720 Williamson
Certificate of Appropriateness
October 16, 2023

Proposed Work

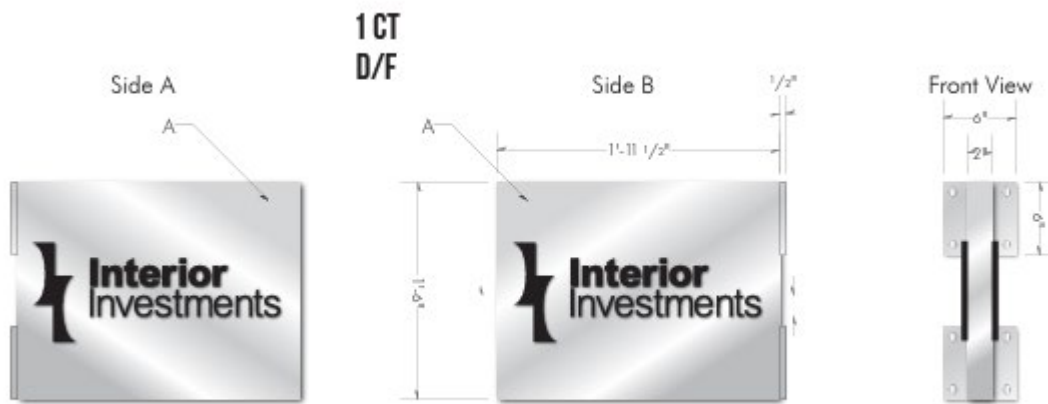
- Installation of a blade sign in pilaster next to entrance

Install Location 10' 1" from Grade

Staff believes that the standards for granting a Certificate of Appropriateness are met and recommends the Landmarks Commission approve the project with the following conditions.

1. Signs be attached to the building at masonry joints using stainless steel fasteners
- ~~2. Approving option 2 for the wall sign with the letters attached to a bar that would then be attached to the building.~~
